4. **Development Permit with Variances Application No. 000382 for 2560 Quadra Street**

**To:** Council **Date:** November 12, 2015  
**From:** Jonathan Tinney, Director, Sustainable Planning and Community Development  
**Subject:** Development Permit with Variances Application No. 000382 for 2560 Quadra Street

**Subject:** Development Permit with Variances Application No. 000382 for 2560 Quadra Street

**Re: 2560 Quadra**

Elevations

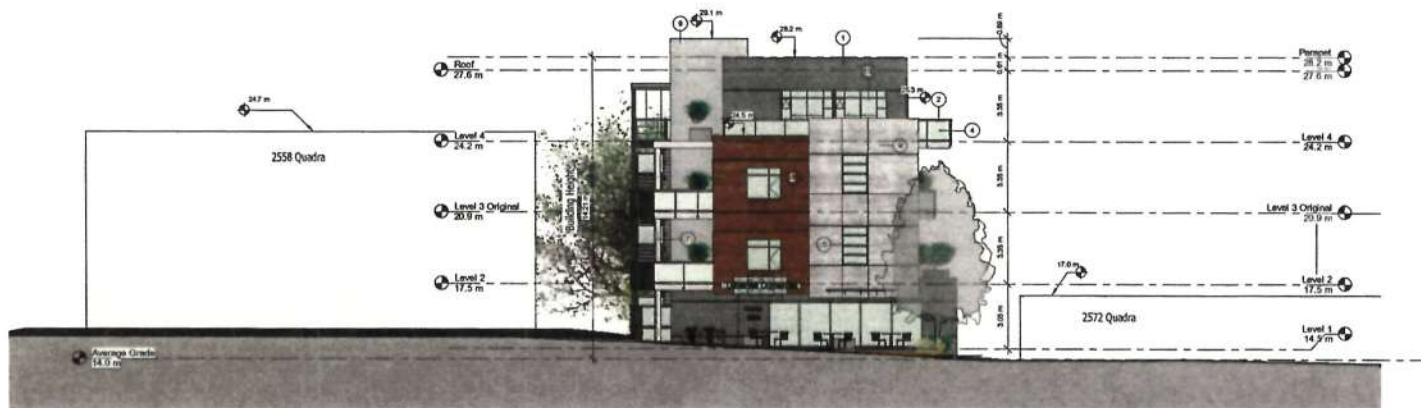
- Item No. 2      The panel suggested raising the parapet walls to screen the planter pots on L2 would be a cleaner architectural expression. The parapet walls on L2 have been raised to screen the planter pots.

Elevations

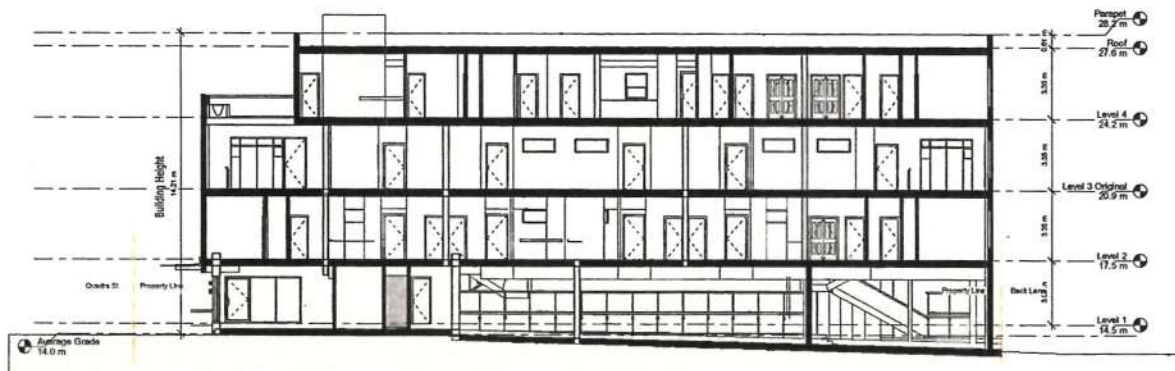
- Item No. 1      The panel wondered if providing a roof over each exterior exit stair on the south face of the building would provide weather protection rendering the stairs more functional. Roofs have been added over each stair as extensions to the existing, lower eyebrow roof on the south face of L4. An open glass trellis links the stair roof and the eyebrow roof.
